**Re: Mirror Lake Parking Expansion Project (#D25-009)**

We have completed our initial review of the above-mentioned application. Below are the comments from the DEC and MassDevelopment. Review comments on the stormwater design from our peer review engineers are being provided in a separate letter.

Example:

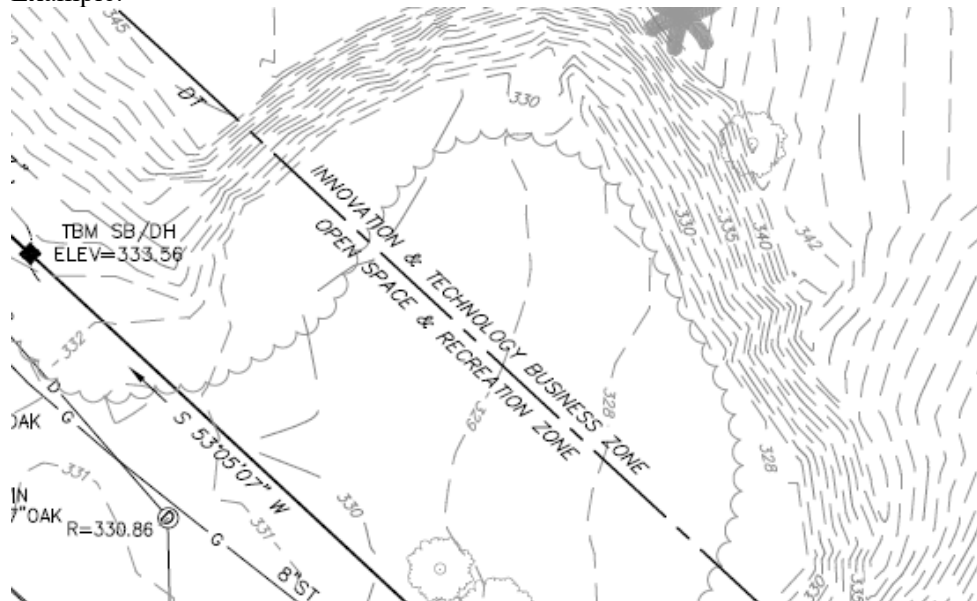
1. The address is 98 Patton Road (all plans list 89).
2. Include area of existing impervious surface and area of new pervious pavement in zoning summary chart.
3. Show Zoning District boundary on plan and label zones along line to clearly distinguish:
